SERVICE INFORMATION BULLETIN

APPLICABILITY: 2018MY Crosstrek

NUMBER: 12-233-18R

SUBJECT: Door Opening Body Flange Weatherstrip-
Design Change

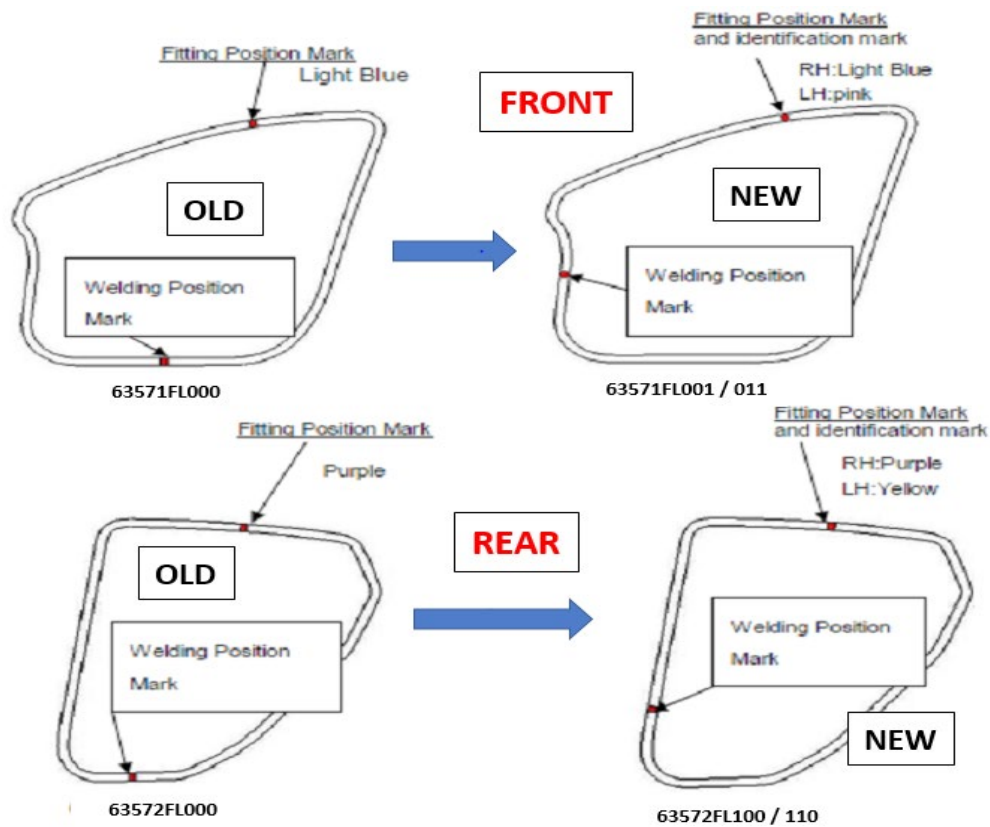
This bulletin announces a design change to the front and rear door body flange weatherstrips in response to concerns regarding the doors being somewhat difficult to close fully. The new parts make closing the doors easier while maintaining a tight seal against air and water intrusion and reducing outside road noise levels in the cabin.

The previous versions of these weatherstrips were the same part number for the left and right. The new parts are made individually for each door opening flange (R/F, L/F R/R and L/R). The differences between the old and new parts are provided in the illustrations below.

IMPORTANT: Always confirm the Fitting Position Marks are installed in their proper positions as shown in the illustrations above.

Description	Part Number	Applicability
WEATHER STRIP BODY SIDE FLANGE	63571FL001	R/Front
	63571FL011	L/Front
	63572FL100	R/Rear
	63572FL110	L/Rear
